**Subject: Safety Recall 03V-472  
(Ford Number 03S08)**

**SUBJECT:** Advance Notification: Safety Recall 03S08:  
All 1996 - 2003 Model Year Ford Crown Victoria Natural Gas Vehicles  
Addition of Insulator

**SUBJECT:** Safety Recall 03S08:  
Certain 1996 through 2003 Model Year Ford Crown Victoria Compressed Natural Gas (CNG) Vehicles  
Insulator Installation

FIGURE 1

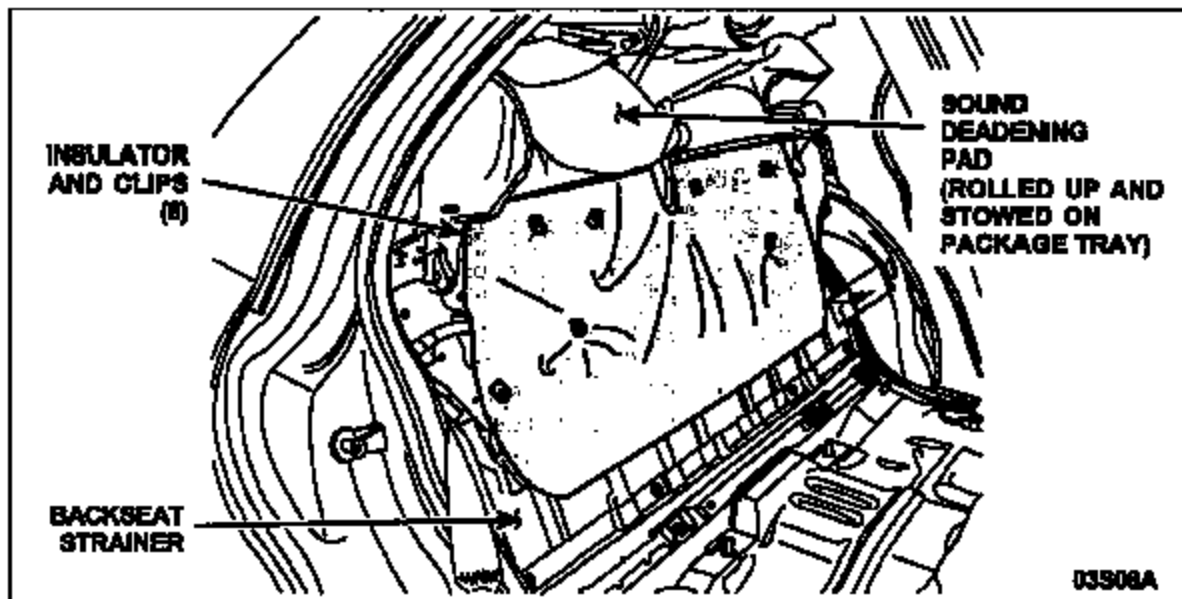
Position and center the insulator on the backseat strainer. Align the retainer holes and install the eight (8) clips. See Figure 1.
